**ATTABAD LAKE
HYDROPOWER PROJECT
(54 MW)**

**FEASIBILITY REVIEW /
VALIDATION REPORT
(FINAL)**

DOCUMENT NO.: 4464-FRR

MAY 2023

Figure 7.1: Feasibility stage Project Layout Alternative-1A

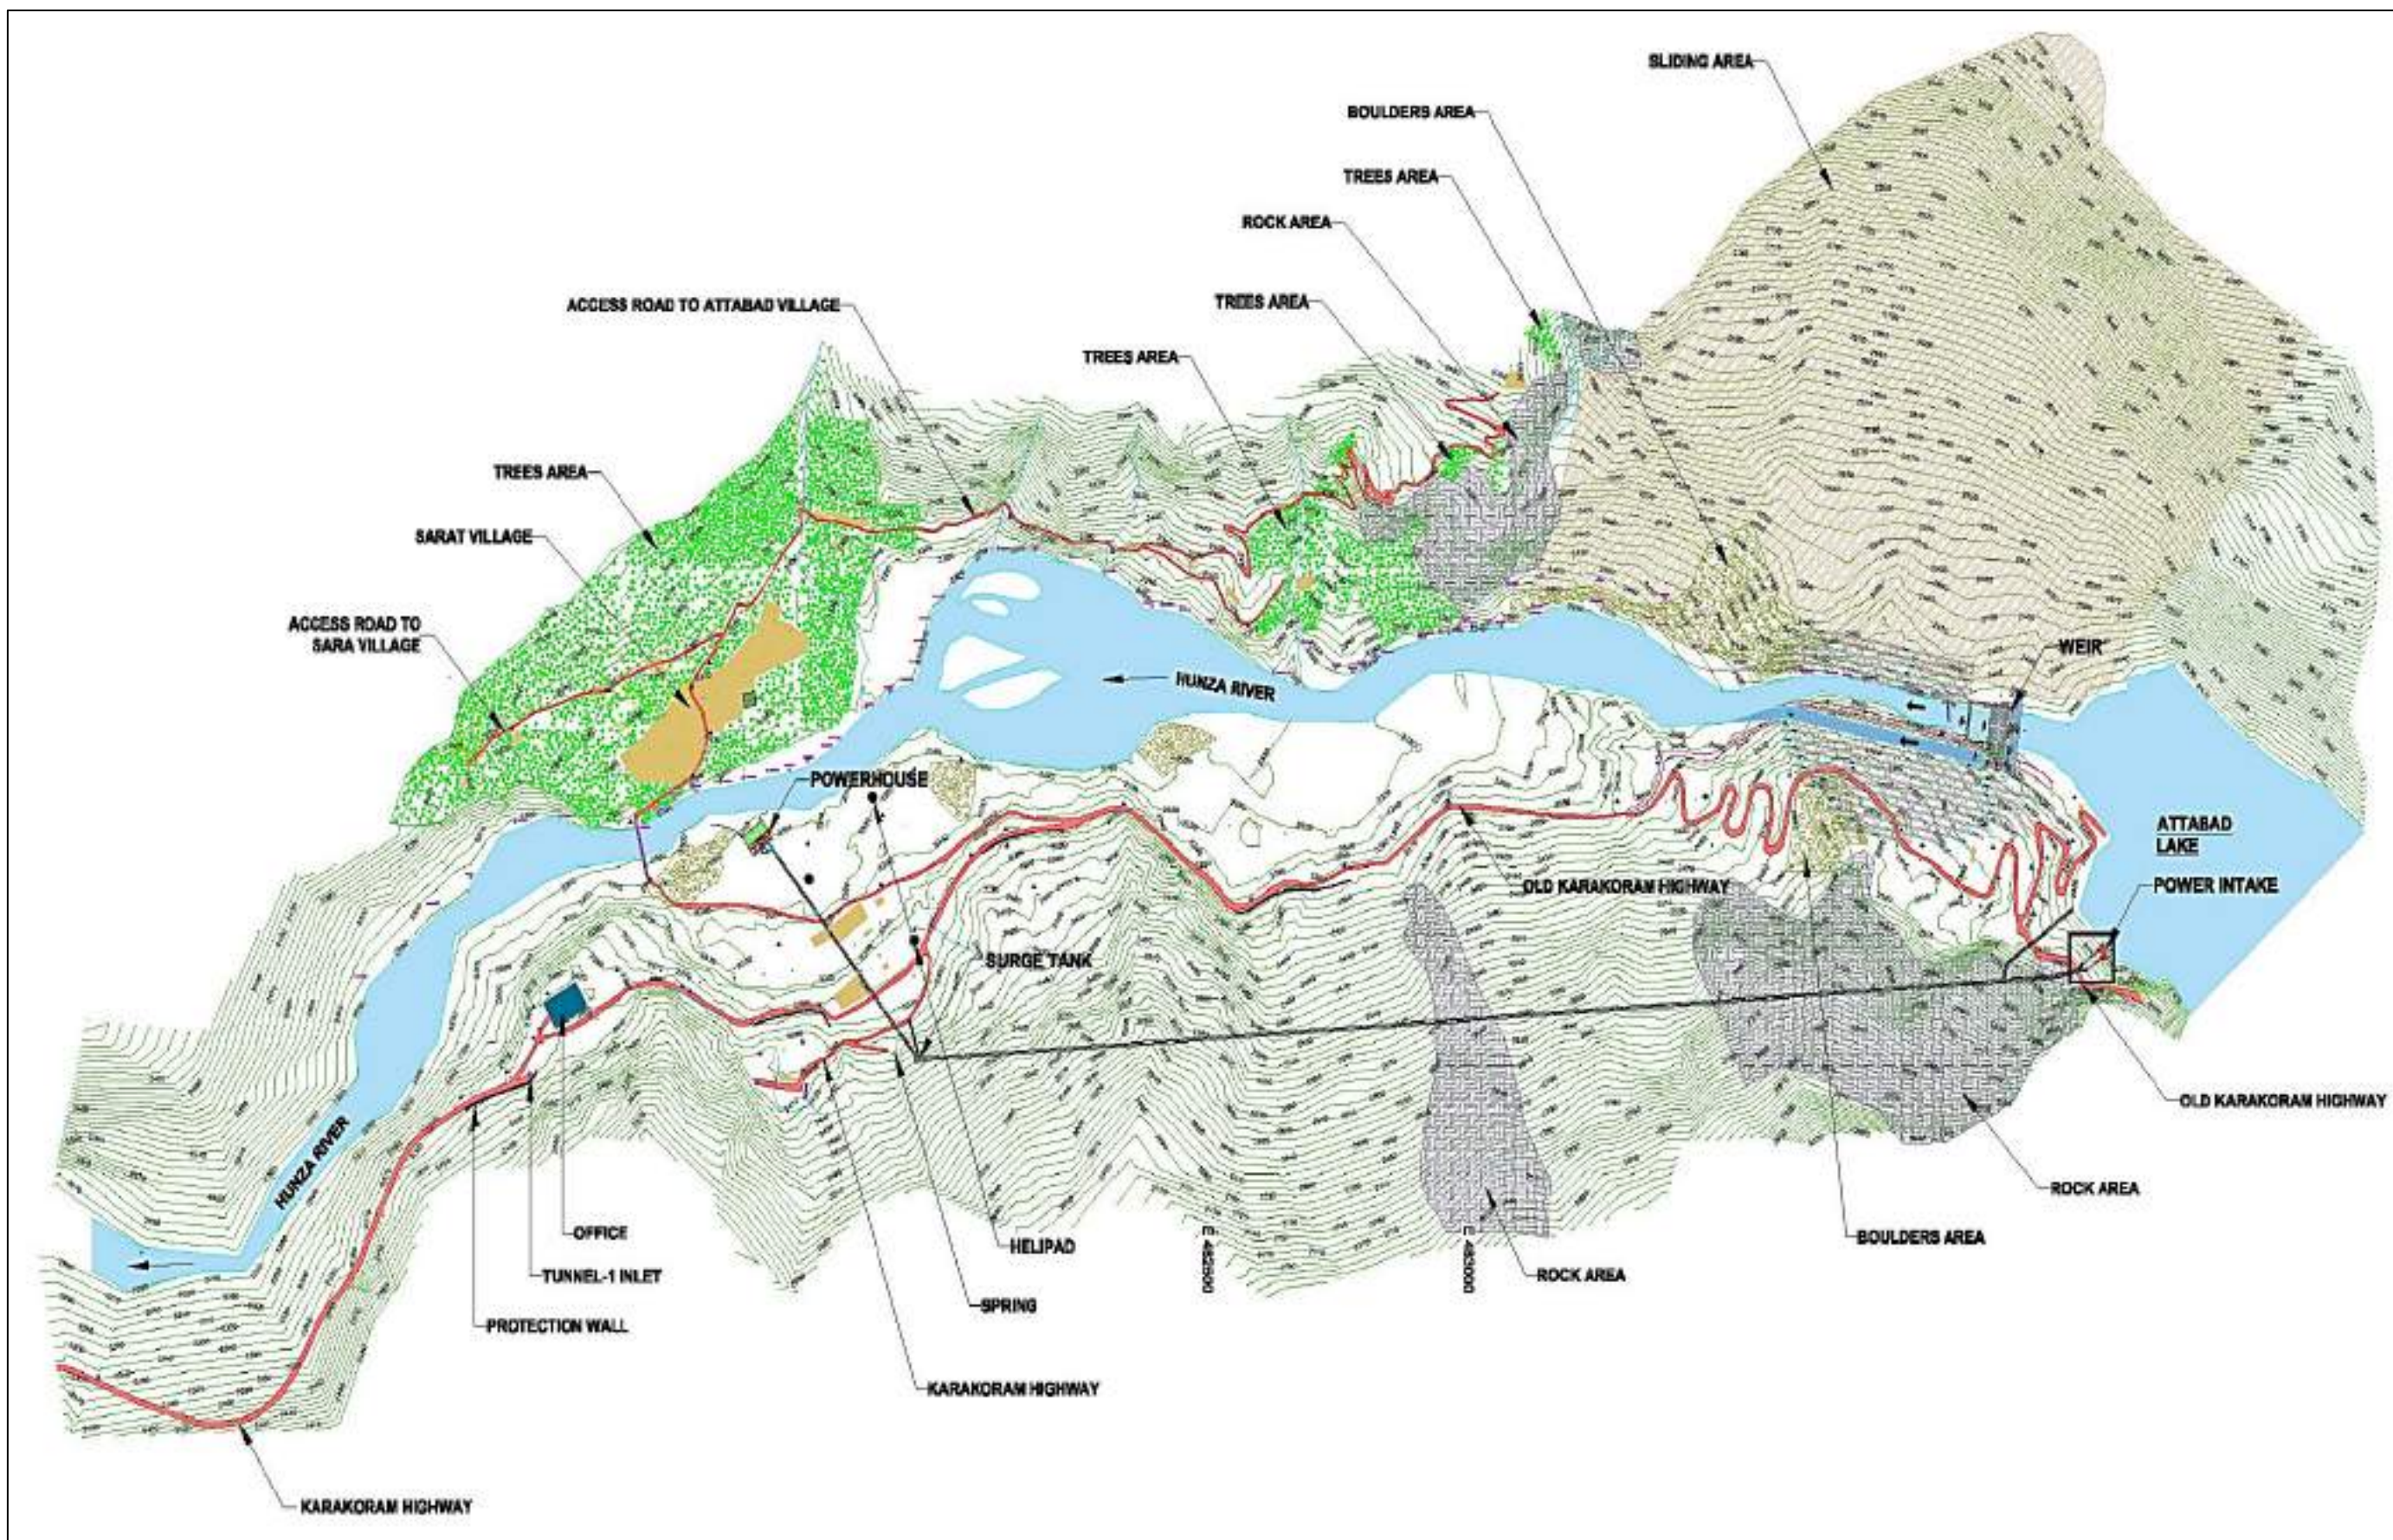
Although, the location of the crest of the proposed Weir and the approach channel were visible, the spillway chute area was inaccessible due to collapse of a portion of the track that runs along the edge of the spillway excavated by FWO. This only reinforces the need for stabilizing the embankment, particularly, in the region of proposed weir.

Figure 7.15: Proposed Modified Alternate-1A layout

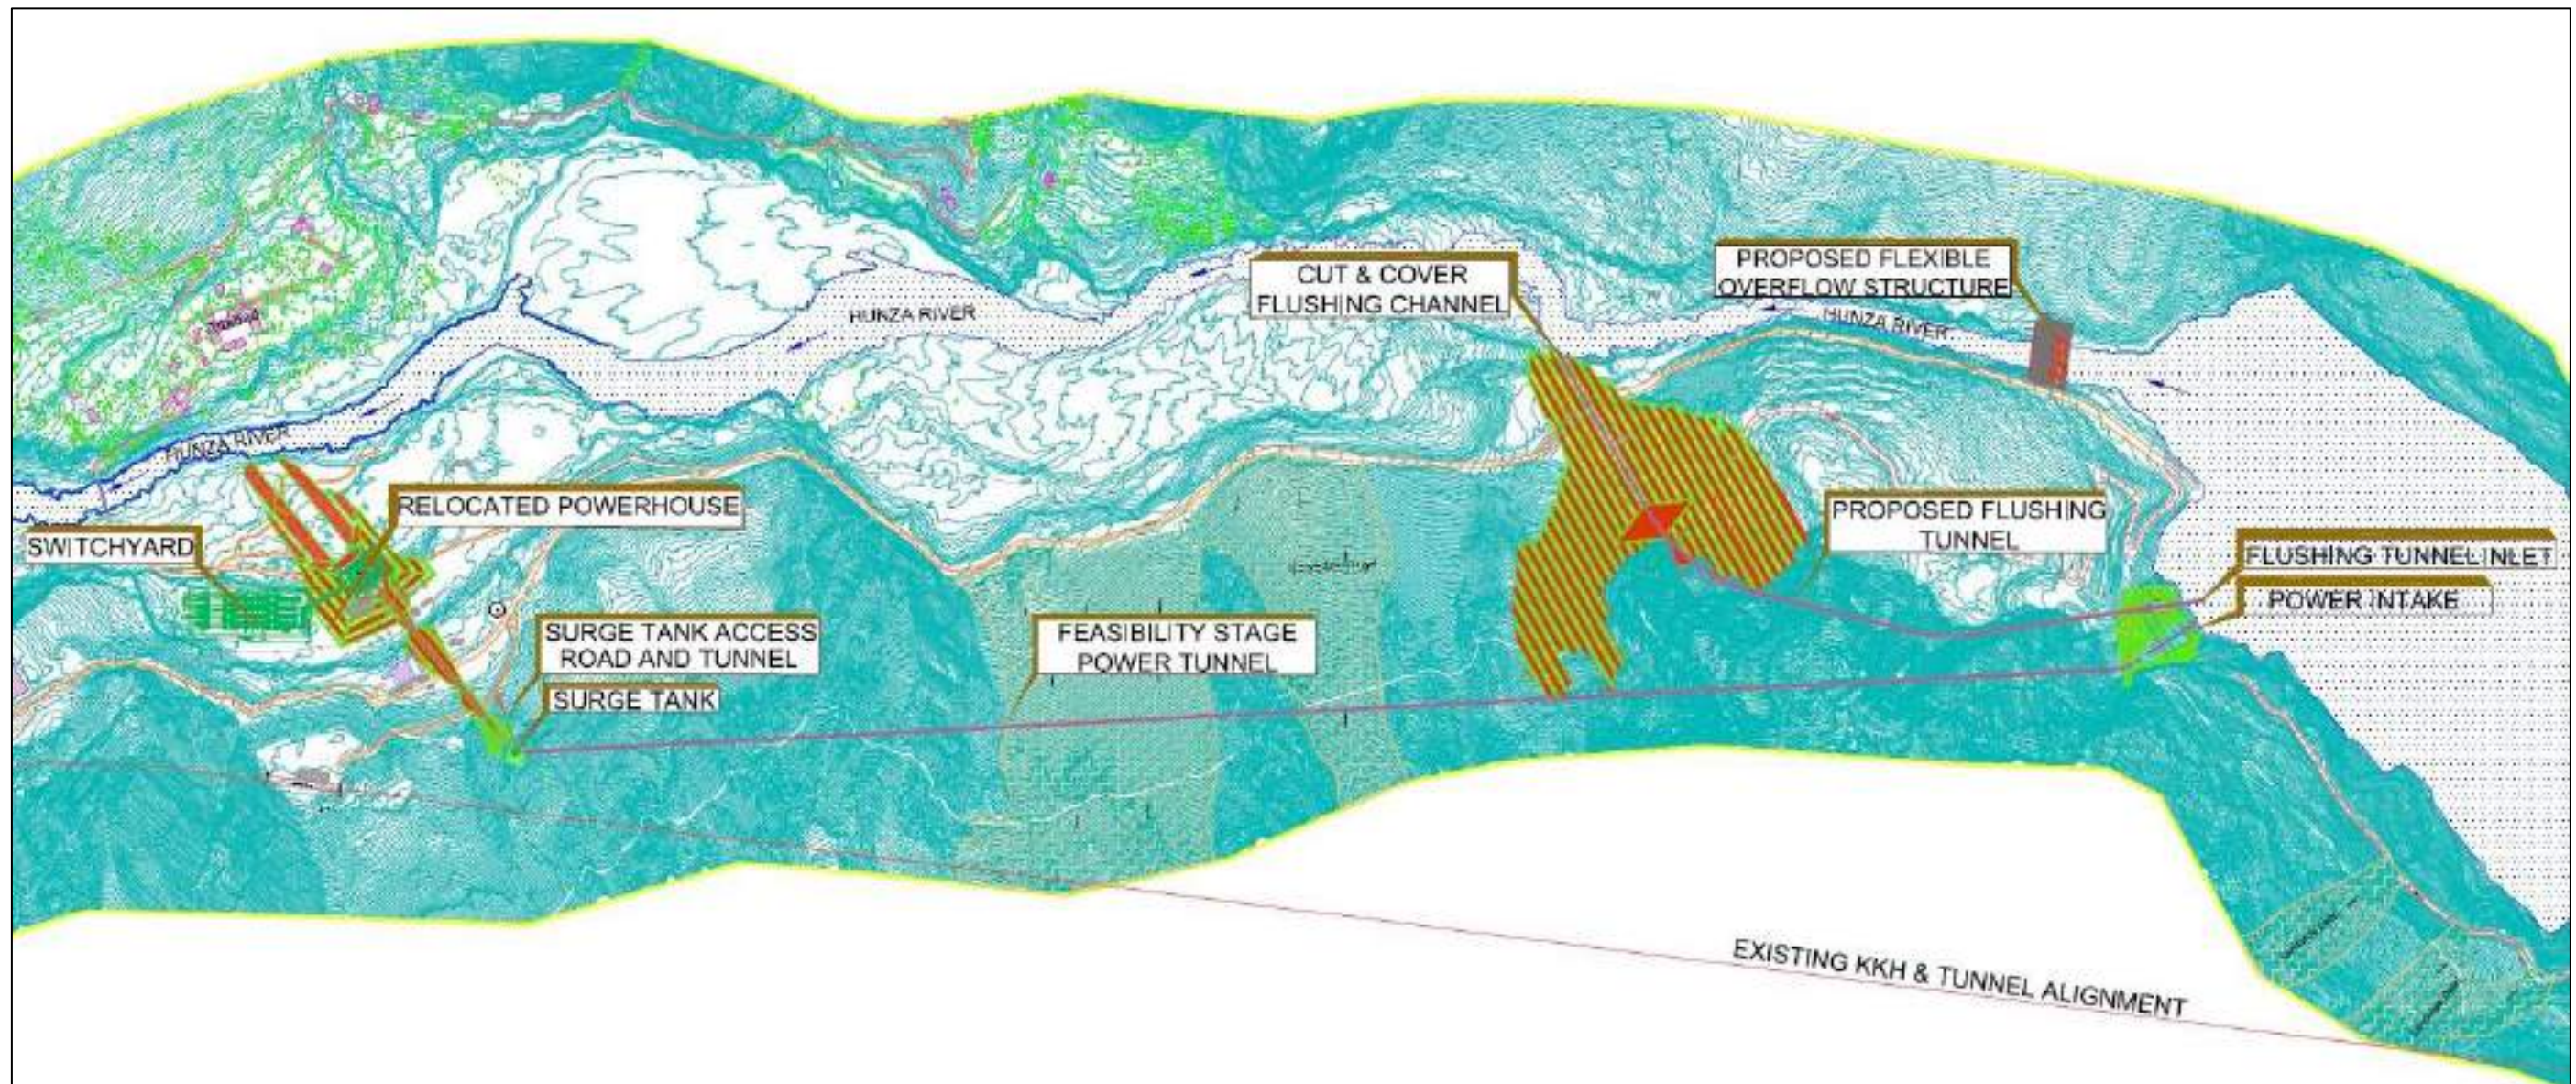
A modification in Feasibility stage Alternative-I A layout is proposed by MC based on described review findings and site visit observations. The layout modified by MC is “Modified Alternate-I A” and is presented in figure 7.15. The modifications are to be checked for technical and economic viability during Detail design stage by EPC Contractor. Following are components of this proposal and recommendations for Detail Design are also given.

A schematic drawing showing the proposed modifications in Feasibility study Alternative-I A layout is presented in Figure 7.15 as “Modified Alternate-1A layout”.

If intake structure is moved to Weir location and in case all slide material washes away then in this scenario considerable time will be required for restoration of Weir/Dam for generation of power.
